# **MUNICIPAL SOLID WASTE PERMIT MAJOR AMENDMENT-2<sup>ND</sup> NOD RESPONSE**

***NAME OF PROJECT: Beck Landfill***  
***MSW PERMIT APPLICATION NO.: 1848A***  
***OWNER: Nido, LTD (CN603075011)***  
***OPERATOR: Beck Landfill (RN102310968)***  
***CITY, COUNTY: Schertz, Guadalupe County***  
***Major Amendment: March 2023***

**REDLINE/STRIKETHROUGH VERSION**

DRAWN BY:	MFV	CHECKED BY:	AWM	APPROVED BY:	AWM	FIGURE NO.:	<b>C3-2</b>
DATE:	08/2022	DWG SCALE:	AS SHOWN	PROJECT NO.:	311-653

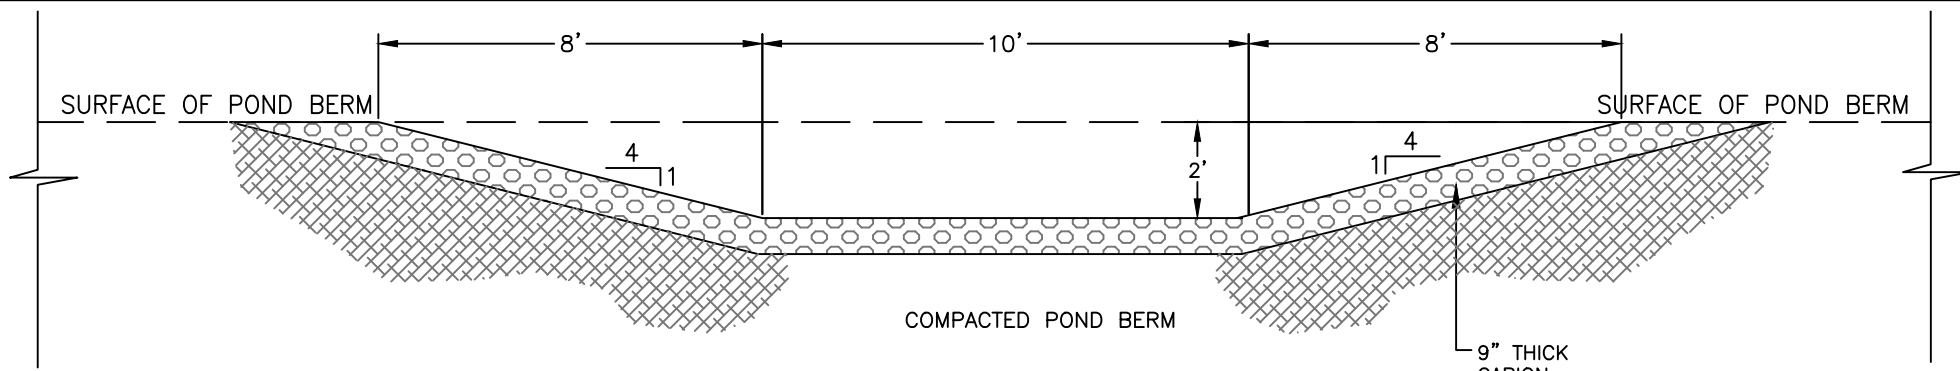
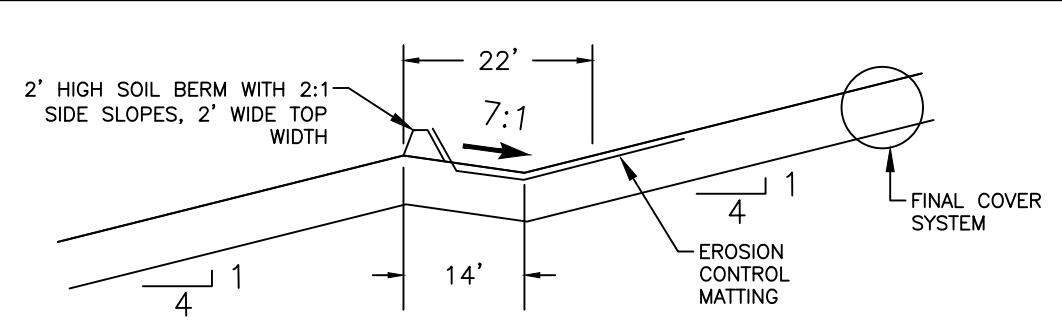
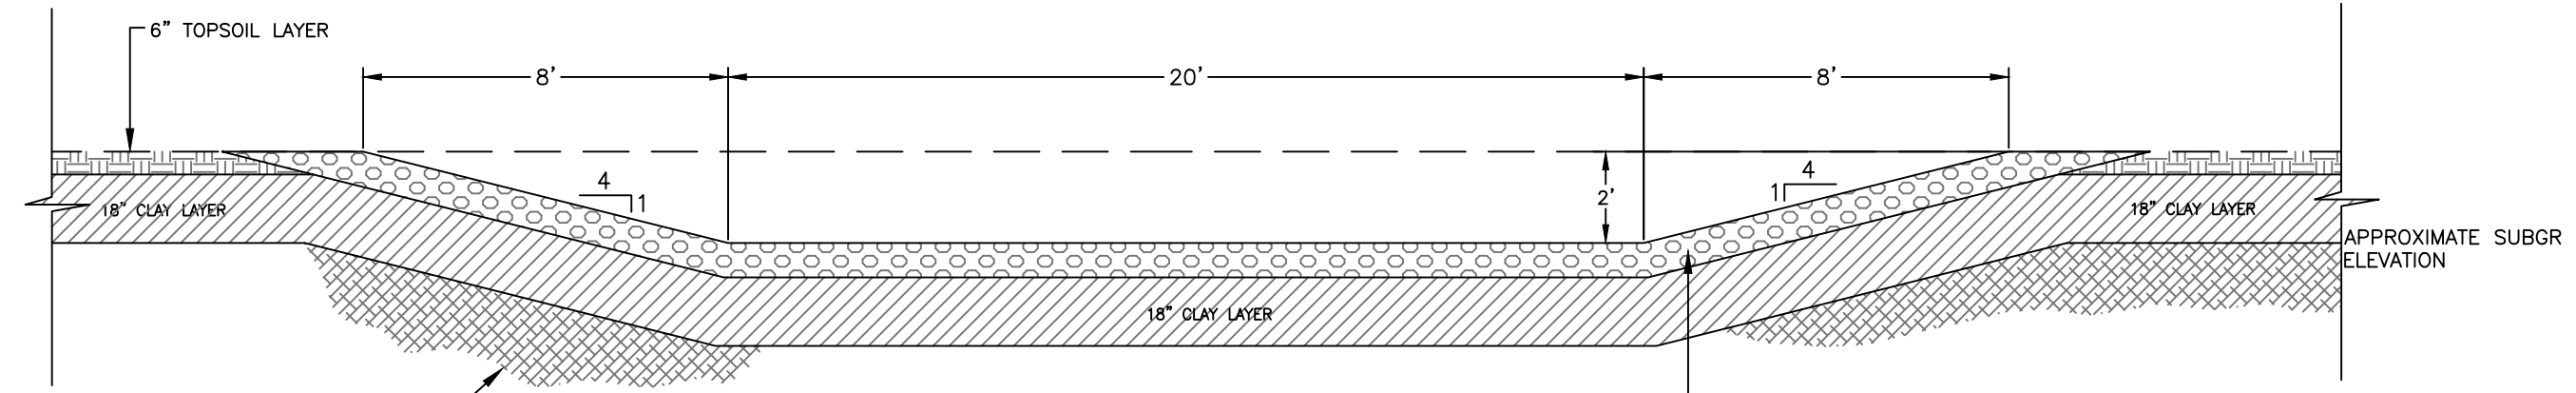
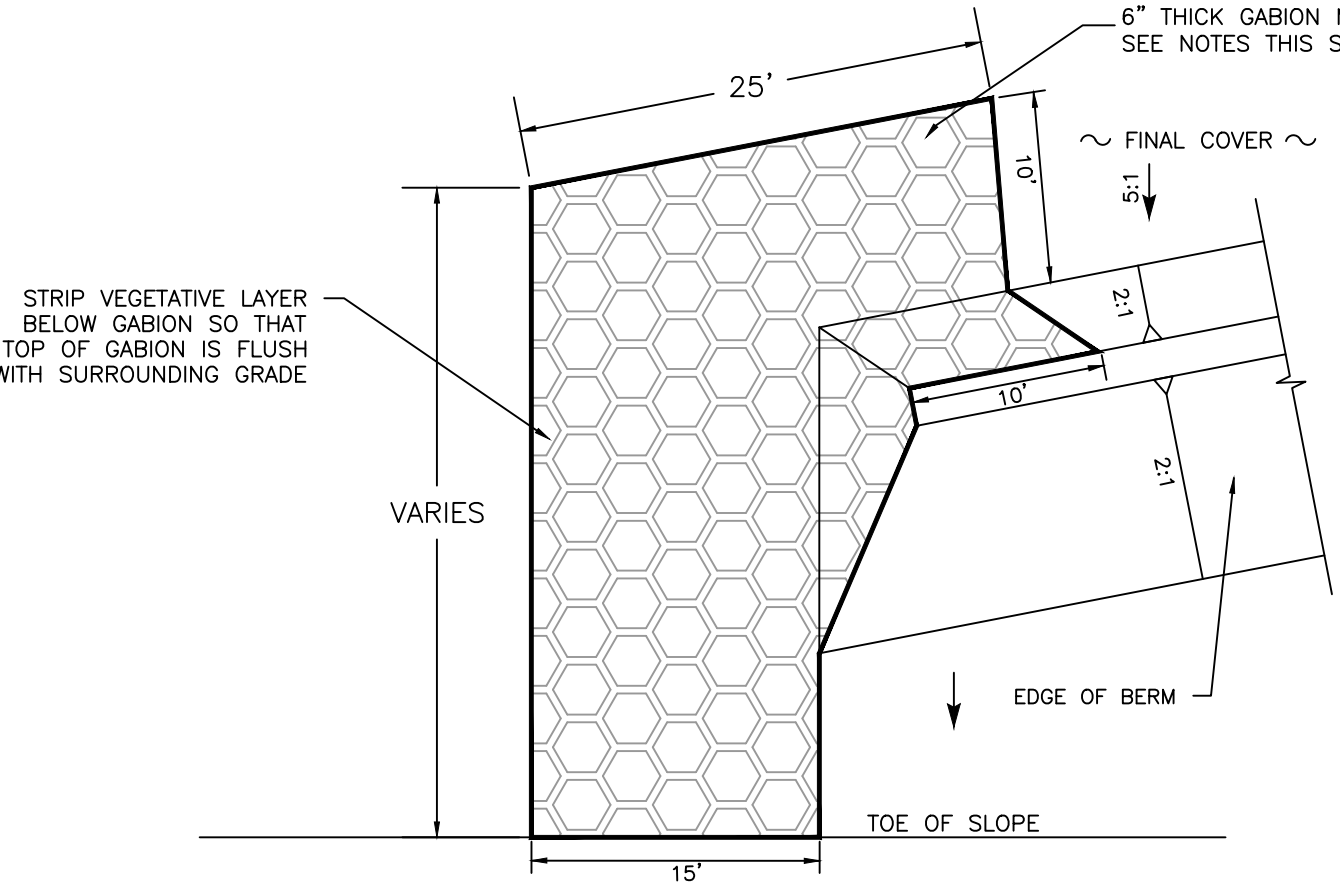
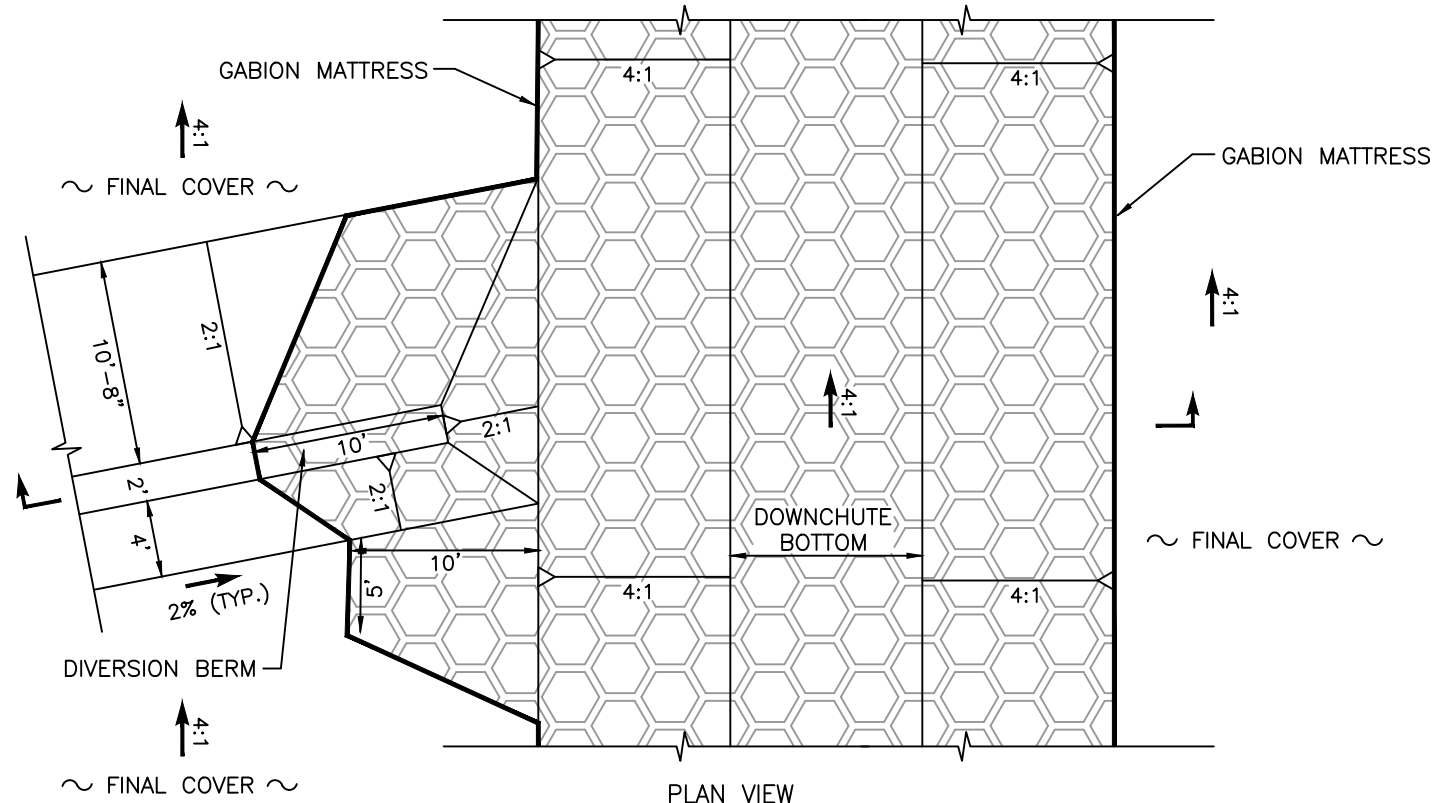
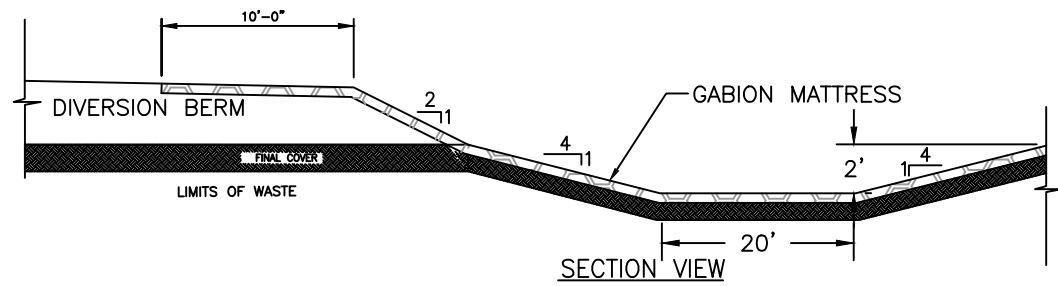
20	313	Part III	330.63(c)(1)(D)(iv)	Appendix C1-D and C1-E	Incomplete	Provide designs (including cross-sectional details) for intersections of chutes and berms/benches on slopes, and perimeter berm. Note that the slopes of the sides and toe will be graded in such a manner as to minimize the potential for erosion.	New details for the tie-in between the perimeter berm and the downchutes and the benches and the downcure have been included as Figure C3-2A.
21	316	Part III	330.63(c)(2)(C)	Attachment C2	Incomplete	a) Provide information detailing the specific flooding levels and other events (e.g., design hurricane projected by Corps of Engineers) that impact the flood protection of the facility.	The predicted flooding in this area is not based on a design hurricane. It is developed based on predicted rainfall in the Cibolo Creek watershed. The rainfall levels that create the 100-year flooding levels are included in Attachment C1.

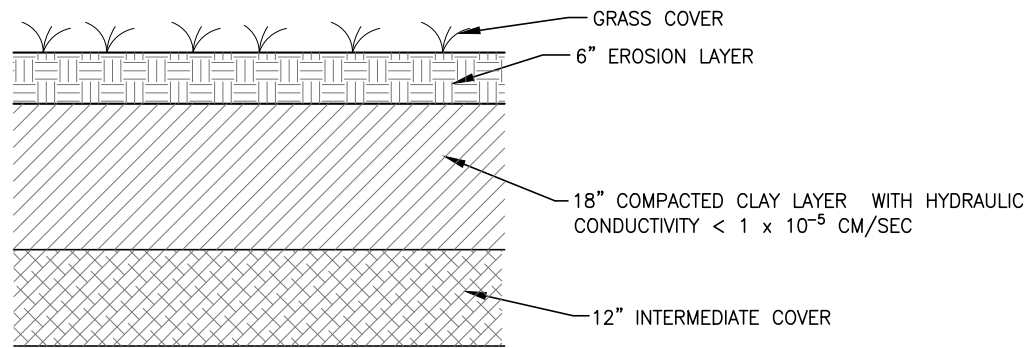
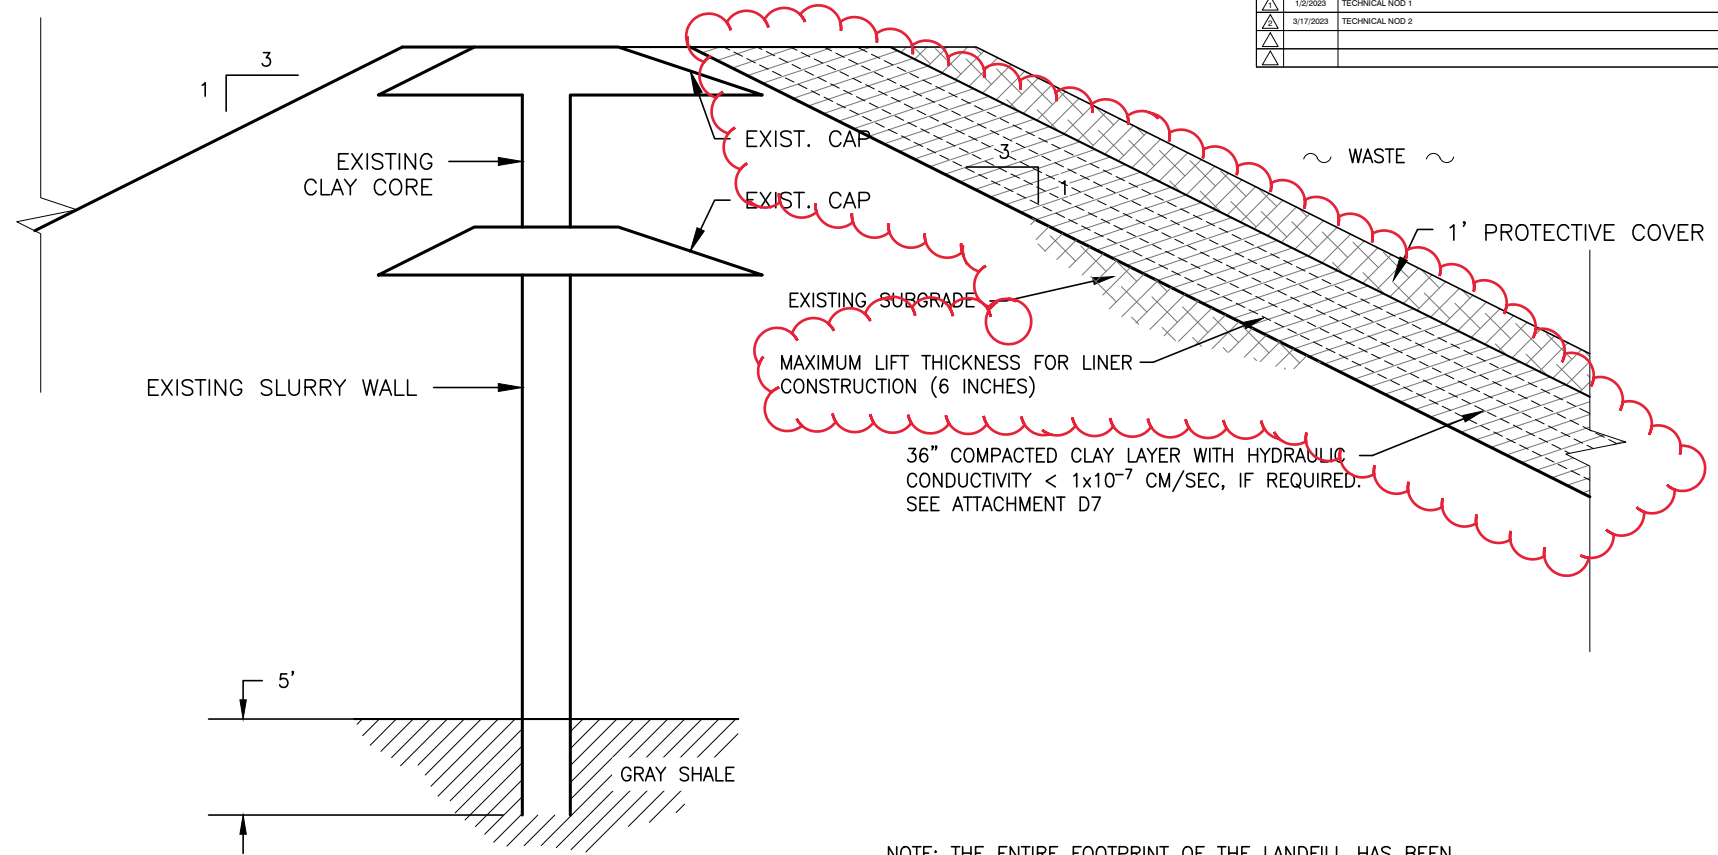
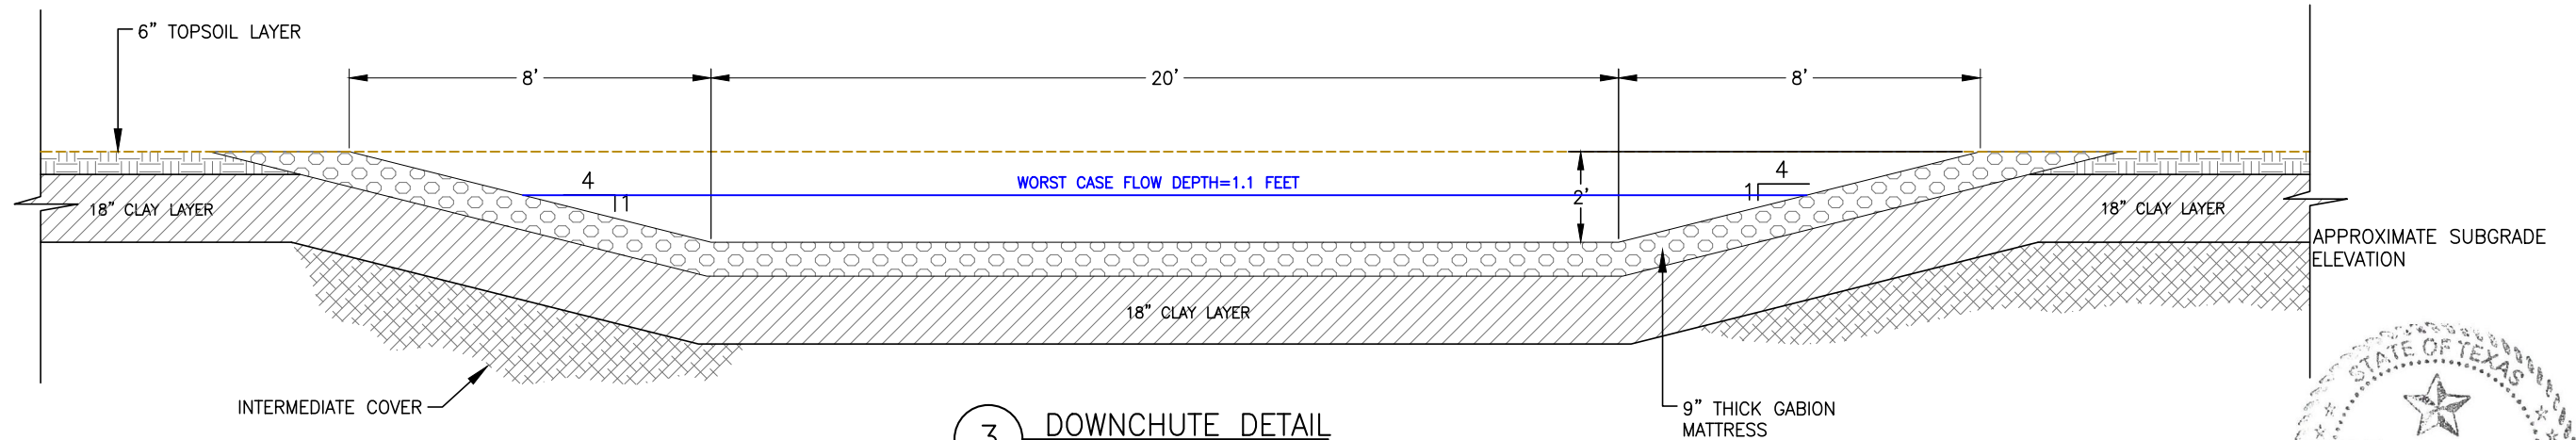
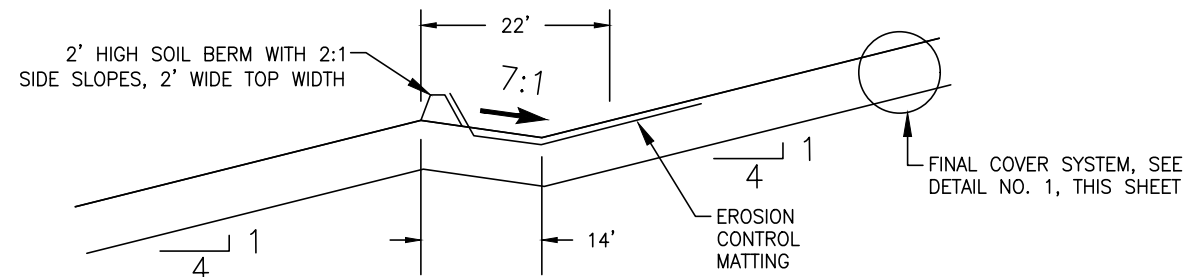
b) Describe for the dimensions (e.g., 10', 14', 22', etc.), as indicated for cross-section of Typical Perimeter Berm (Figure C1-2A), and for Typical Bench (Figure D3.1).	Typical Perimeter Berm on Sheet C1-2A: 2' is the top width of the berm and the height of the berm. 10' is the top width and height of the additional soil dike being constructed to protect the waste from the floodplain. See Figure D-2 for additional information on proposed 10' high soil dike. Typical Bench on Sheet D3.1: 7' is the width of the portion of the bench sloping back toward the landfill at 7:1. 22' is the total width of the bench.
16	299	Part III	330.305(f)(1)	Attachment C1	Incomplete	Revise the chute design calculations using Rational Method for the worst-case flow conditions, as the largest contributing area appears to be 66.3 acres, or include discussion in narrative application to justify using HEC-HMS for designs of chutes.	A Rational Method Calculation for this downchute has been added to Appendix C1-E. The calculated peak 25 year flow via the Rational Method is 338.8 cfs. A new Flowmaster calculation for this downchute that utilizes the Rational Method flowrate has been inserted in Appendix C1-E.

<b>FINAL COVER TIE-IN DETAIL</b>			
DRAWN BY: MFV	CHECKED BY: AWM	APPROVED BY: AWM	FIGURE NO.: <b>D3.2</b>
DATE: 03/2023	DWG SCALE: NTS	PROJECT NO: 311-653

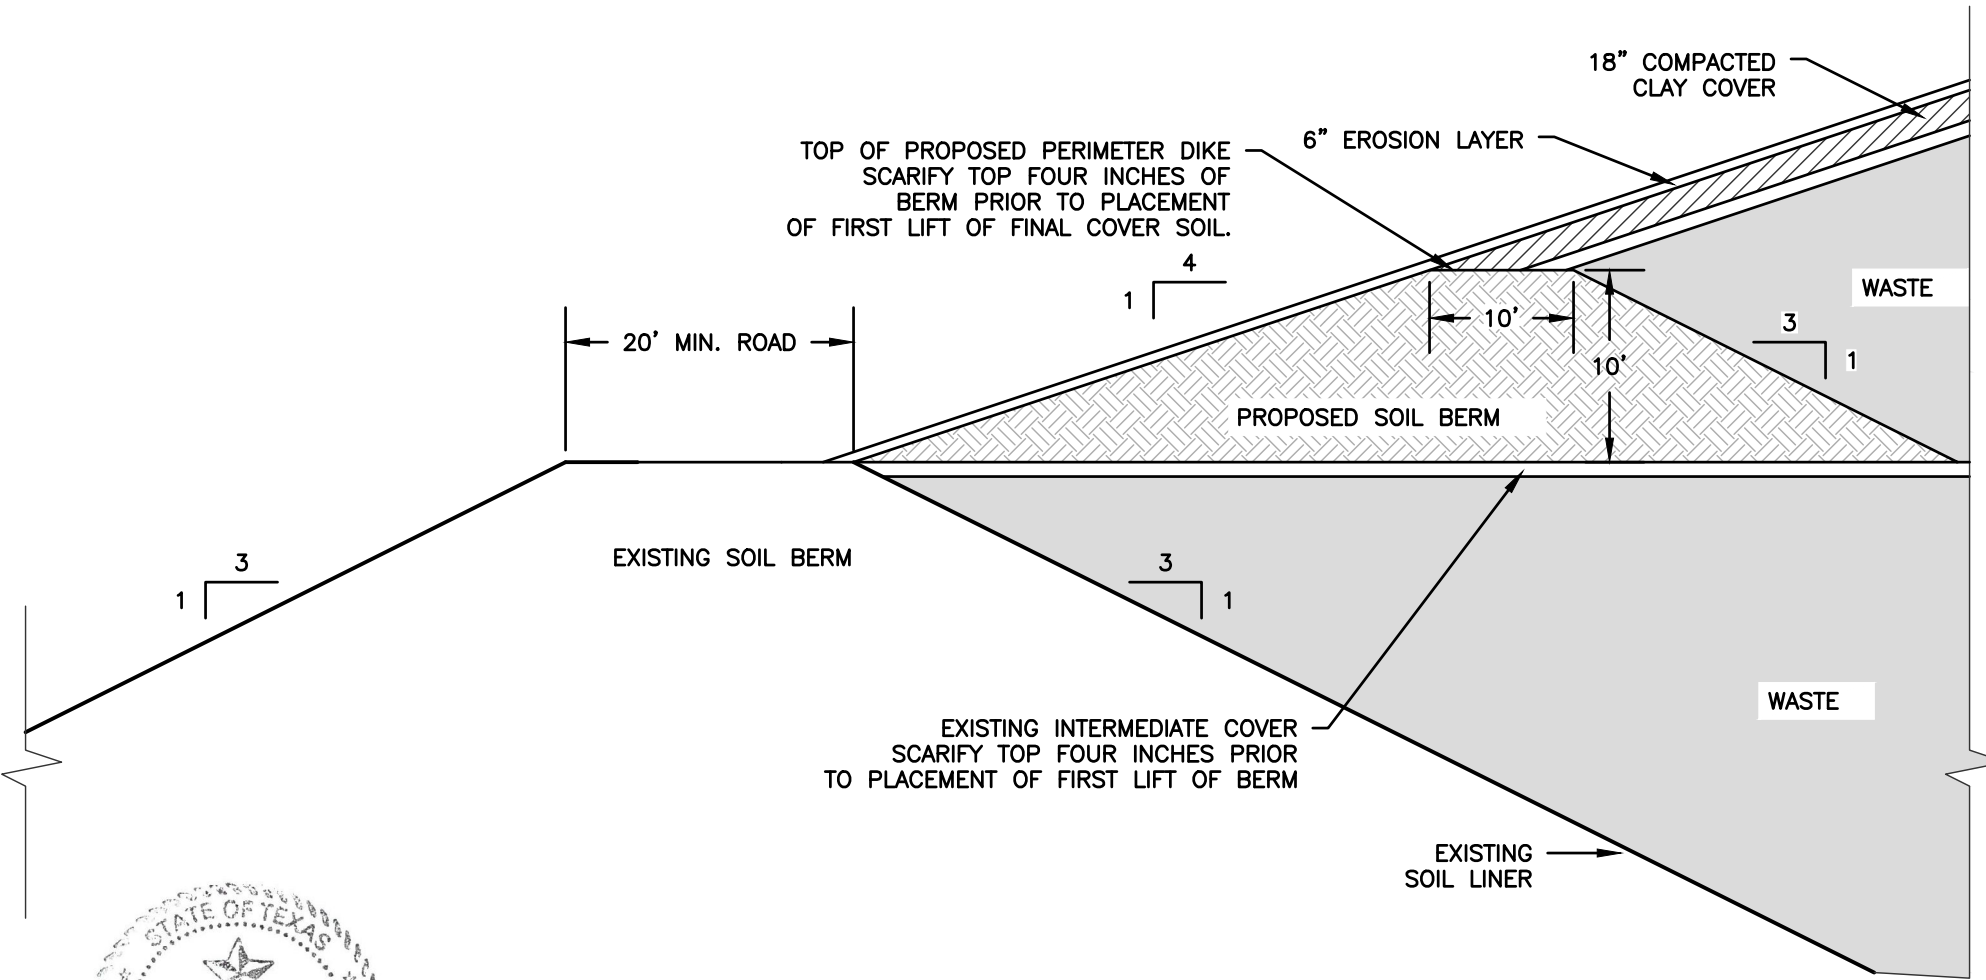
b) Since the detention pond construction is proposed in the floodway, provide a Corps of Engineers Section 404 Specification of Disposal Sites for Dredged or Fill Material permit.	Based on the information provided in Part II, Attachments J & K there are no wetlands or other federally jurisdictional features in the area near the proposed pond, so a permit for dredging or filling under Section 404 is not required.
24	351	Part III	330.63(d)(4)(E)	Attachment D2	Incomplete	Soil borings, groundwater monitoring wells, and gas monitoring probes were not found along the sections on Figures D2-1 and D2-2.	We have included the closest groundwater and methane monitoring wells to the sections, where appropriate.
25	352	Part III	330.63(d)(4)(E)	Attachment D2	Incomplete	Label the slurry wall on Figures D2-1 and D2-2.	The slurry wall is labeled on the left side of each cross-section.
26	356	Part III	330.63(d)(4)(F)	Attachment D3	Incomplete	Figure D3.1. Provide details for the tie-in from the final cover to the existing perimeter berm and the tie-in between the proposed perimeter berm and the existing perimeter berm.	Figure D3.2 has been created to show this information.
